Fire Protection and Water Supply Plan

Addendum 1

Princes Highway, Frogs Hollow

The purpose of this addendum to the Fire Protection and Water Supply Plan is to provide additional information requested by Bega Valley Shire Council (BVSC).

Figure 1- Fire Protection Water Supply

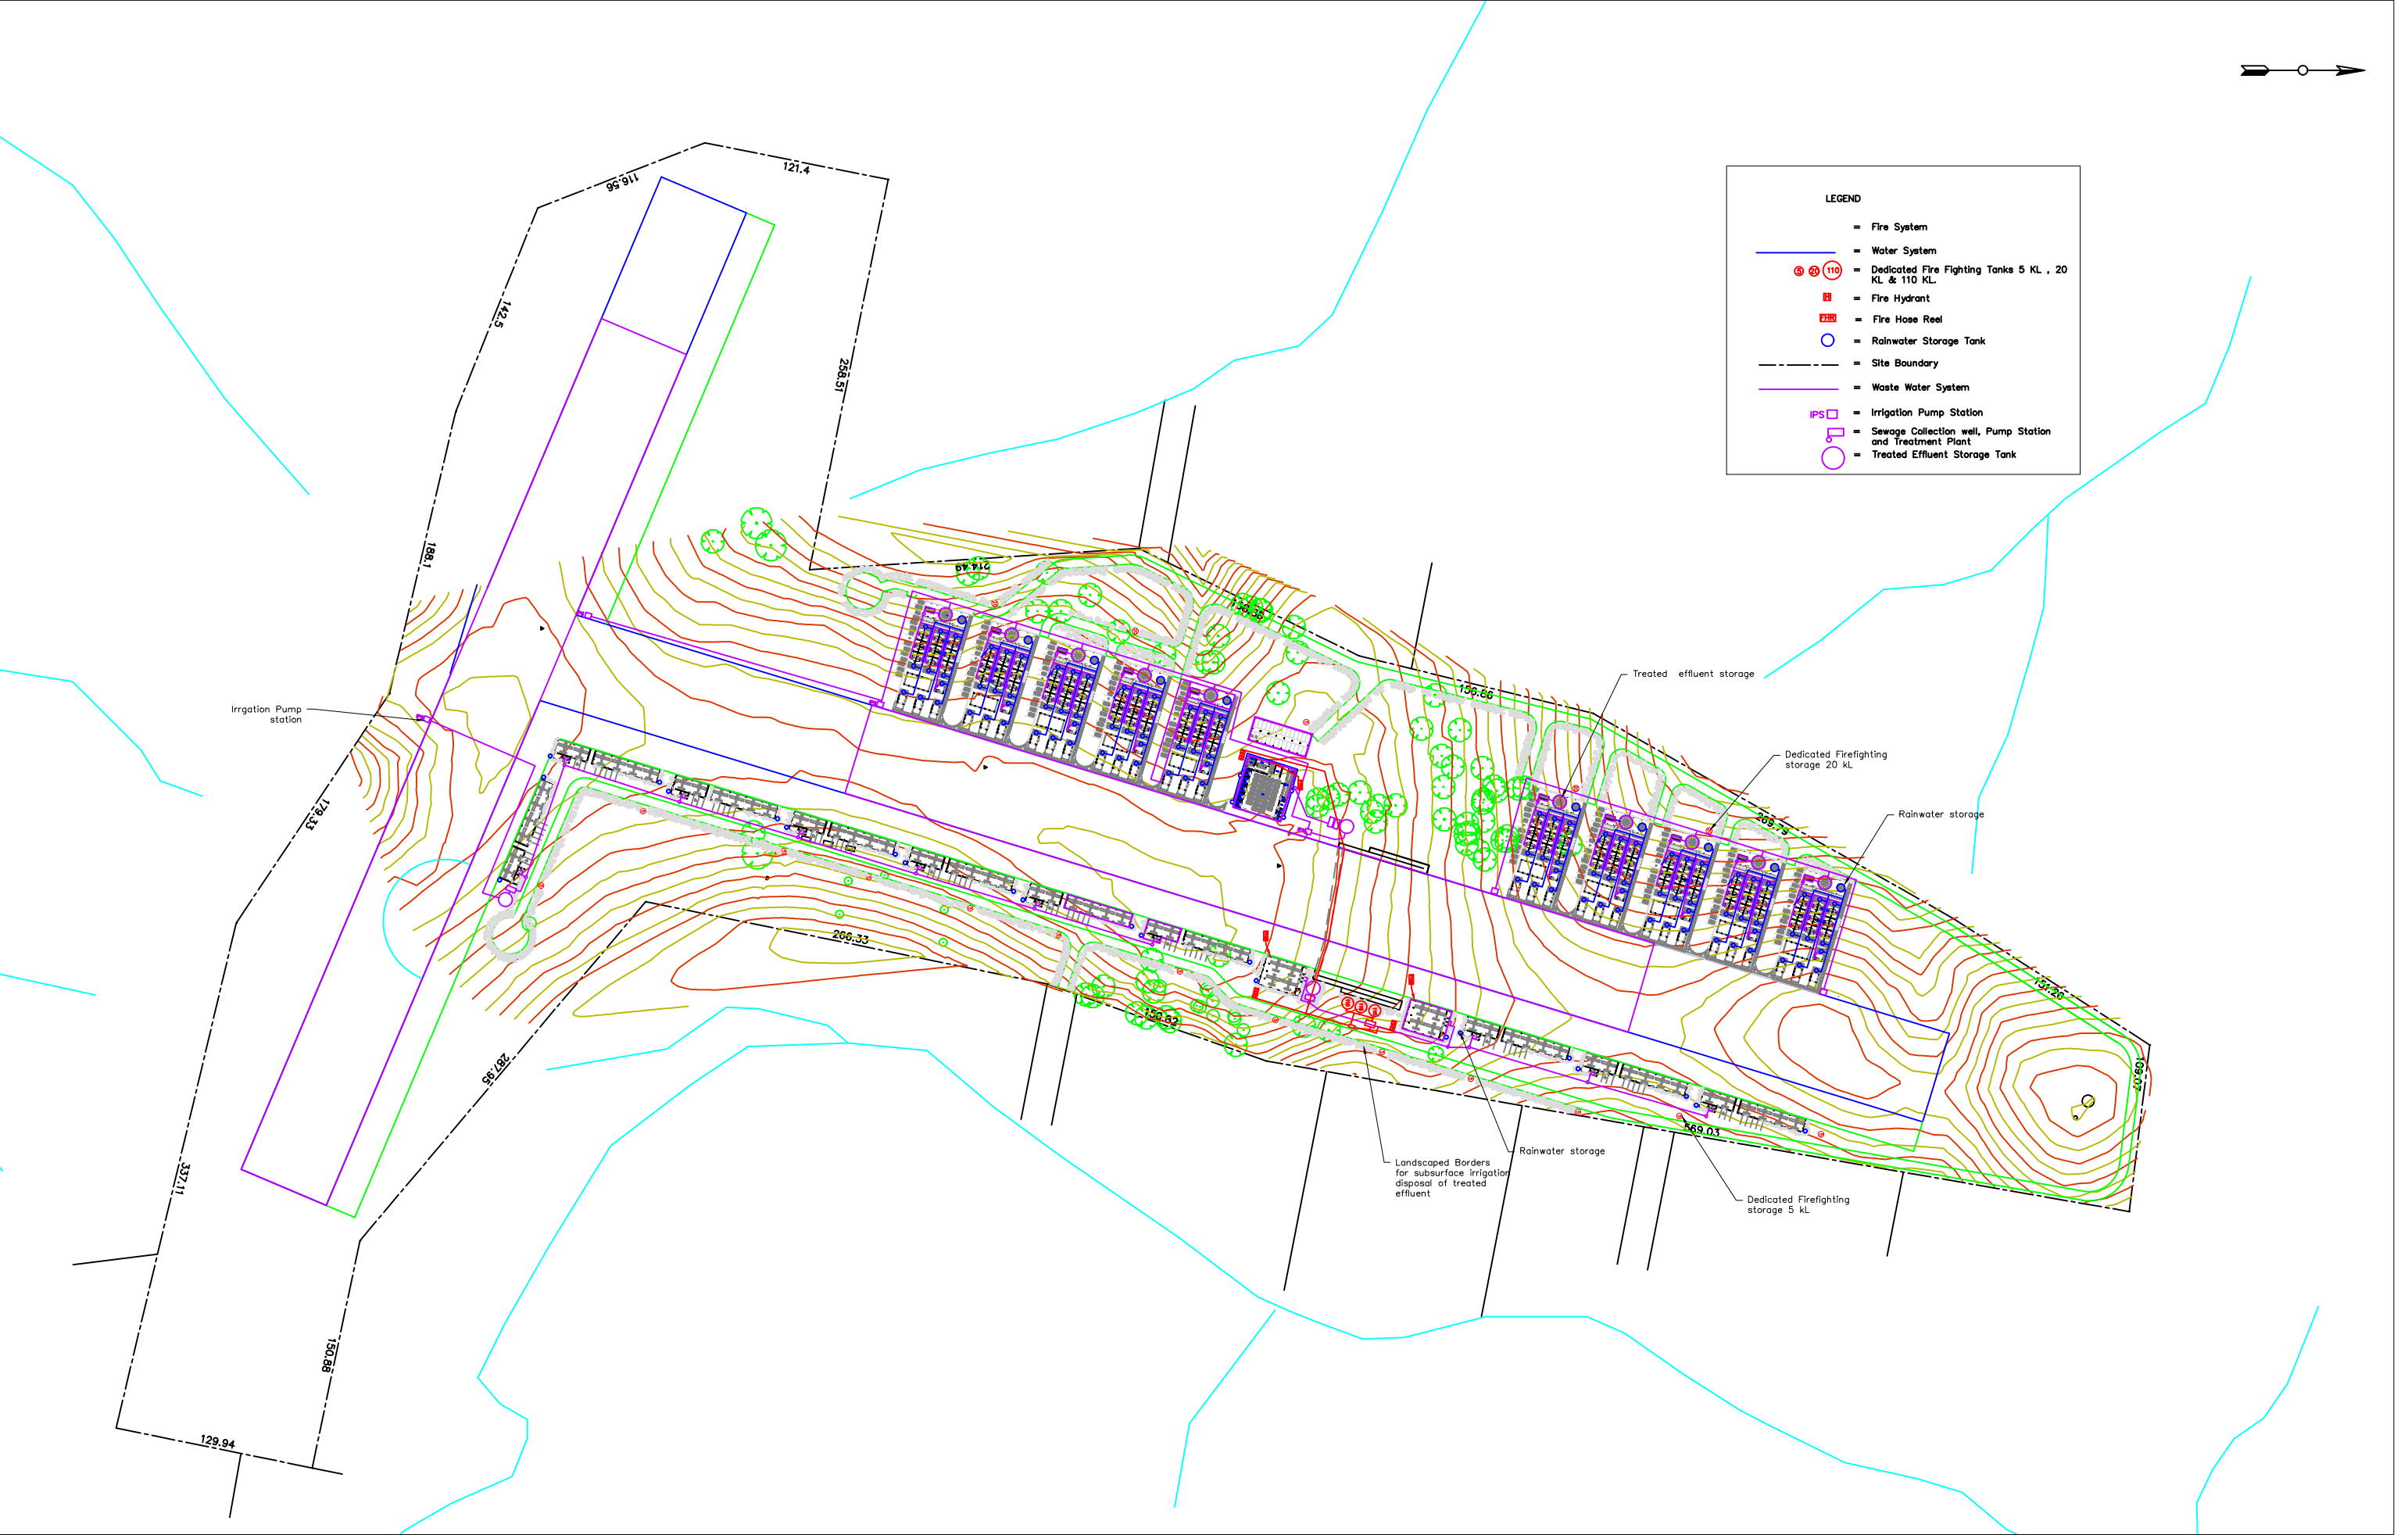
Specifically BVSC has requested the following in relation to fire and potable water supply:

- Information regarding systems for making potable water,
- Preliminary hydraulic assessment for a fire suppression system to insure compliance with NSRF condition 4 of RFS letter dated 11 Dec 2017.

- Two hydrants shall be provided to service each of the Maintenance Buildings as well as the Main Building and Parking Area.
- The Main Building and Workshop Buildings and Car Park also shall be protected by a fire hose reel system to serve all parts of the buildings.

- The pressure and flow requirements are specified as 10 l/s per hydrant at a dynamic pressure of 700 KPa.
- A dual pump set is required and would operate at the design flow of 20 l/s and design pressure of 700 kPa + head loss.

- A AS 2419 compliant booster assembly is required and can be supplied off the shelf.
- A 330 KL water supply is specified in three 110 KL tanks. An additional 150 KI would be available from the stand alone fire water storage tanks at various locations around the site and would provide for the required 50% 24 hour refill volume specified in AS 2419.1-2005.

- Tanks shall have a tank gauge which is visible from the area of the booster assembly.
- The final design would also include an analysis of the piped distribution system to ensure that the pressure and flow requirements are achieved. This includes adjusting the pipe size to achieve the pressure and head loss within the required specification of 150 KPa maximum head loss and a maximum static pressure of 1300 KPa.

- Underground piping shall consist of PN 16 UPVC bell and spigot pipe.
- All above ground piping including hydrant stand pipes shall be steel.
- Trenching details and details of thrust blocks and pipe restraints would be shown in detail in the final design documentation.

Figure 1 shows the components of the fire supply system.
